## Report to Planning and Environment Committee

**Subject:** Sifton Properties Limited  
1938 & 1964 Commissioners Road East  
Public Participation Meeting

**Date:** September 27, 2021

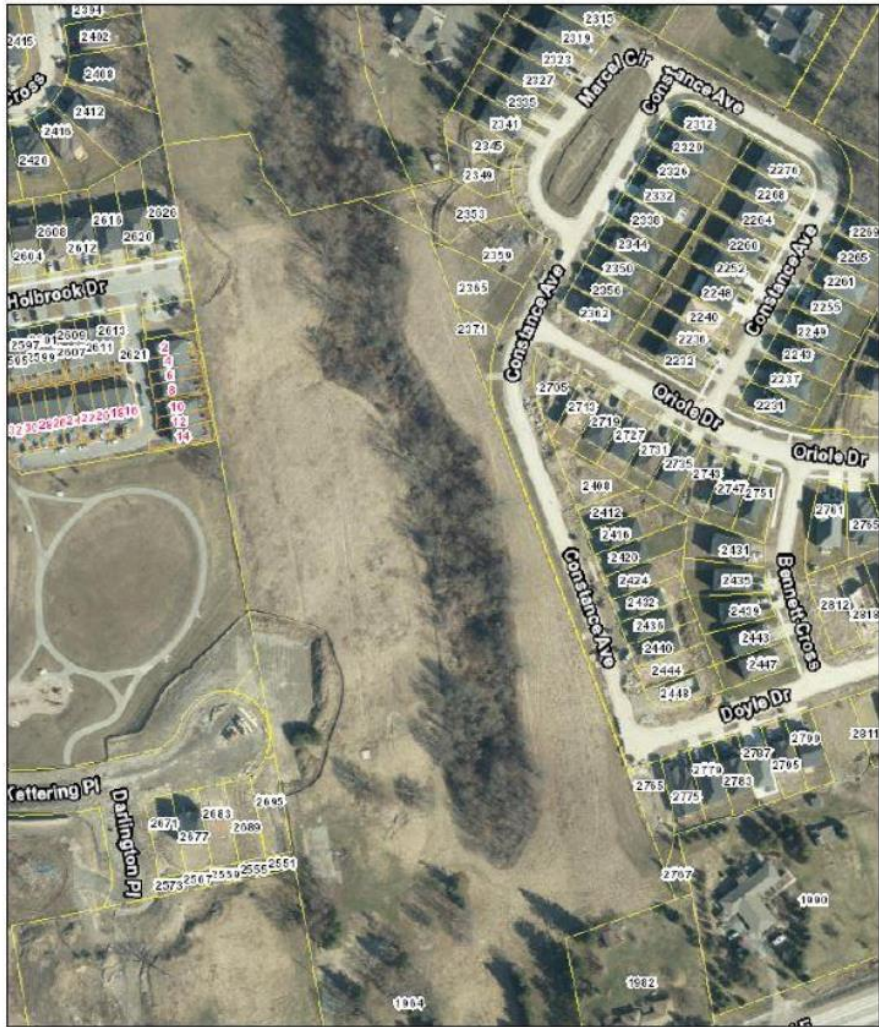
The location of the anuran call count station is not shown on any map either in the original EIS or in the revision. EEPAC also questions the date in Table 8 as it does not match the Environment Canada weather data at London Airport for the days and times listed. Also AECOM indicates in the table of comments that all three surveys were done in 2017. The EIS says the April survey was done in 2018 which is consistent with the weather data from Environment Canada for the day in question.

Figure 7

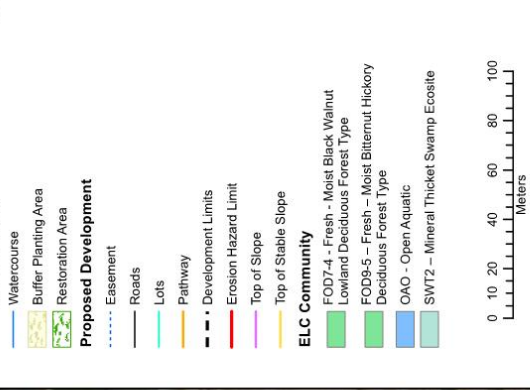
EEPAC agrees with designating Patch No. 09028 as Open Space on the OP, Green Space on the London Plan and zoned as OS(4) and included as a Significant Woodland the relevant maps using the boundaries shown on Figure 7 of the EIS. The boundary of the Significant Woodland and the buffers must also be indicated on Site Plan and construction contract drawings.

- **The boundary shown in the maps of the London Plan include the buffer**
- **the Site Plan and construction contracts also include Figure 7 which show the buffer and restoration areas**
